Landscape Referral Response

Application Number:	DA2018/1481
Date:	15/11/2018
Responsible Officer:	Phil Lane
· · · · · · · · · · · · · · · · · · ·	Lot 2611 DP 752038 , 1 / 0 Veterans Parade NARRABEEN NSW 2101

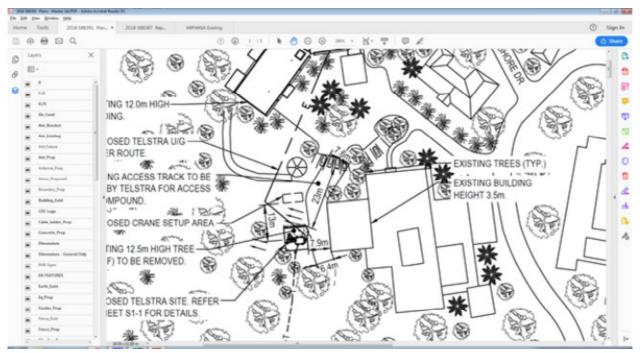
- The plans indicate removal of one 12.5 m high tree, assessed as being 1 x *Angophora costata*, a local native tree.
- The plans indicate that the edge of the development closest to the existing building is 7.9m offset. Looking at overlays on Council's GIS mapping system, this places the development within the E2 Environmental Conservation Zone. In view of the objectives relating to the E2 Zone, the location of the pole and associated infrastructure is not supported.

Extract of DA Site Access Plan. Note the 7.9m offset from existing building to the eastern edge of the development

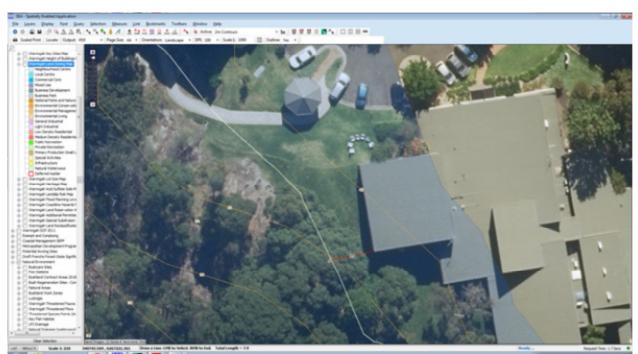
Copy of Air Photo showing 7.9m offset from existing building to the eastern edge of the development. Note intersection with the 40 Contour
